Well Name: HOLLOWAY FEDERAL	Well Location: T27N / R11W / SEC 6 / NWNW / 36.609283 / -108.049759	County or Parish/State: SAN JUAN / NM
Well Number: 1E	Type of Well: CONVENTIONAL GAS WELL	Allottee or Tribe Name:
Lease Number: NMSF078895	Unit or CA Name:	Unit or CA Number:
US Well Number: 3004525827	Well Status: Producing Gas Well	Operator: HILCORP ENERGY COMPANY

Type of Submission: Notice of Intent

Type of Action: Plug and Abandonment

Proposed P&A Procedure

Proposed P&A Procedure

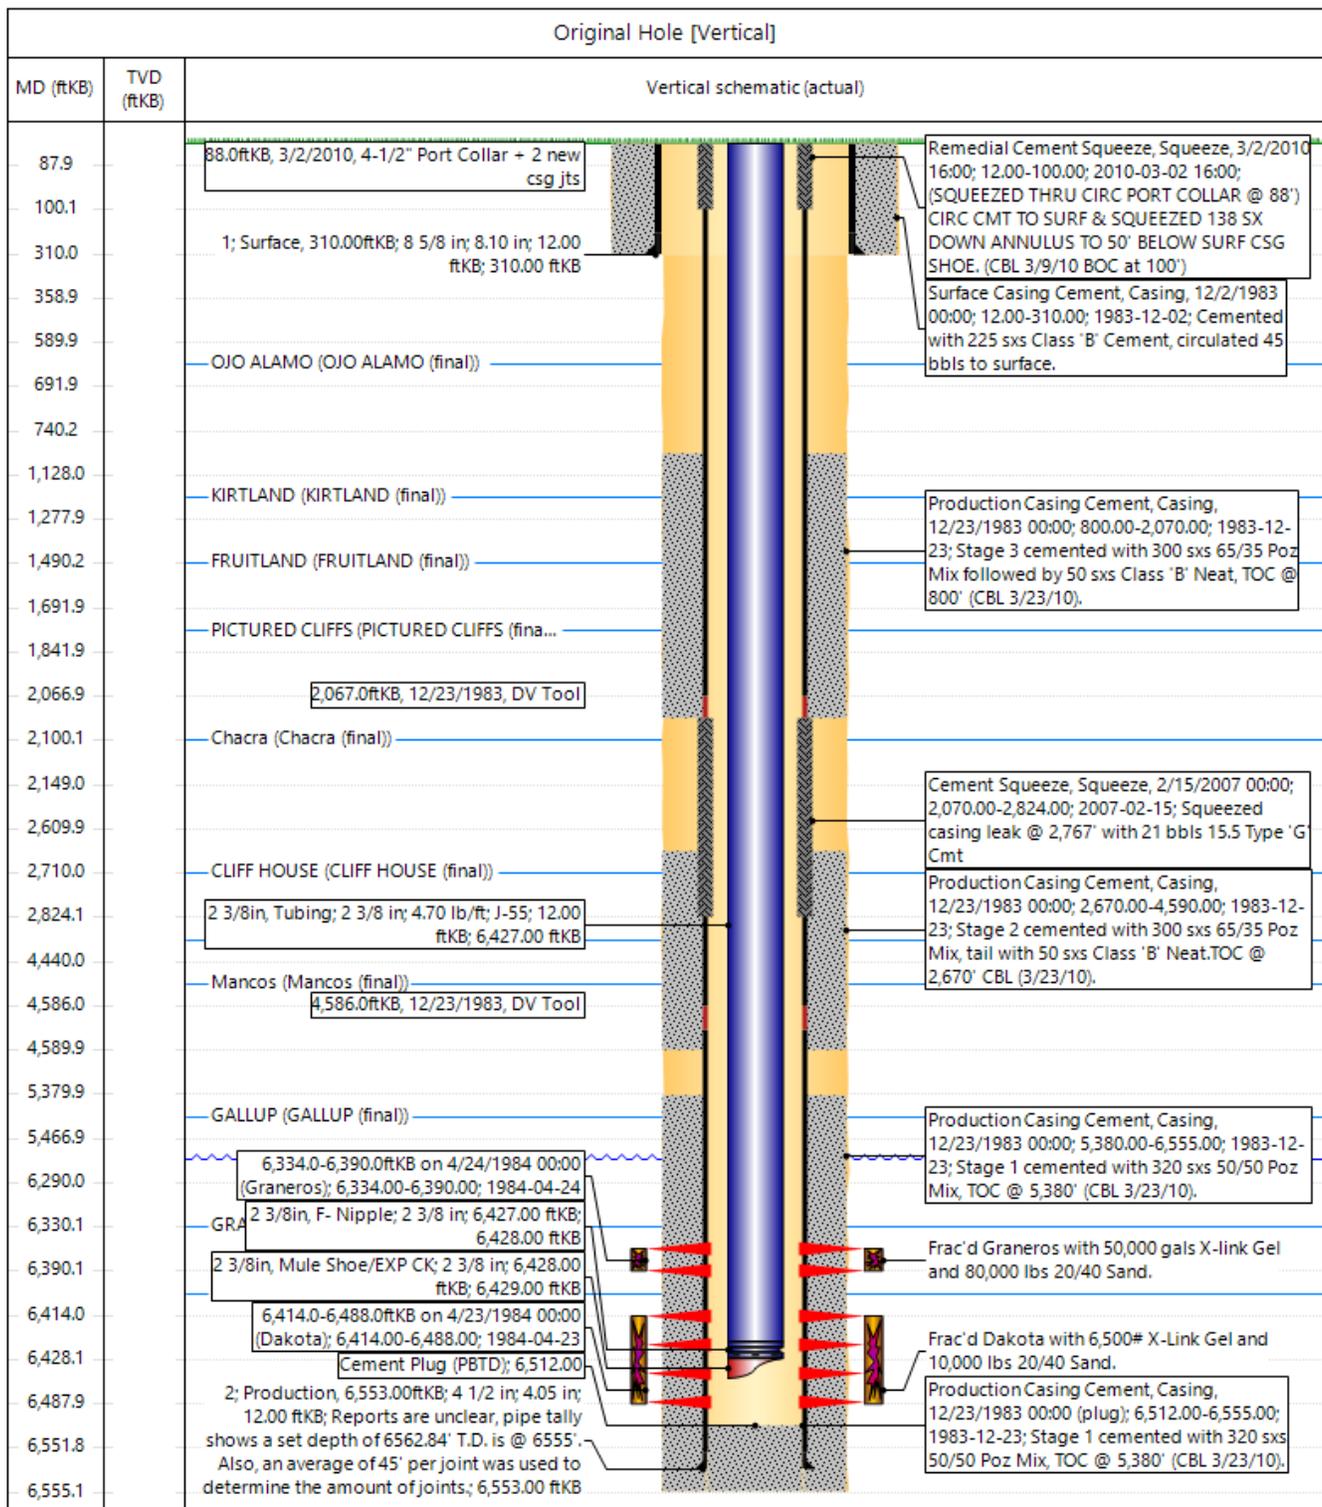
1. Plugging operations authorized are subject to the attached "General Requirements for Permanent Abandonment of Wells on Federal and Indian Lease."
2. The following modifications to your plugging program are to be made:
 - a. Change Plug 4 to run from 3504' to 3354' to account for the BLM Cliff House formation top.
 - b. Change Plug 5 to run from 2839' to 2689' to account for the BLM Chacra formation top.
 - c. Change Plug 7 to run from 1454' to 1304' to account for the BLM Fruitland formation top.
 - d. Combine Plugs 8 & 9 by perforating at 834', setting the CICR at 784', and running cement from 834' to 614' to account for the BLM Kirtland Shale and Ojo Alamo formation tops.
3. Farmington Office is to be notified at least 24 hours before the plugging operations commence at (505) 564-7750.

- Change Plug 4 to run from 3504' to 3354' to account for the BLM Cliff House formation top.
 - Change Plug 5 to run from 2839' to 2689' to account for the BLM Chacra formation top.
 - Change Plug 7 to run from 1454' to 1304' to account for the BLM Fruitland formation top.
 -Combine Plugs 8 & 9 by perforating at 834', setting the CICR at 784', and running cement from 834' to 614' to account for the BLM Kirtland Shale and Ojo Alamo formation tops.
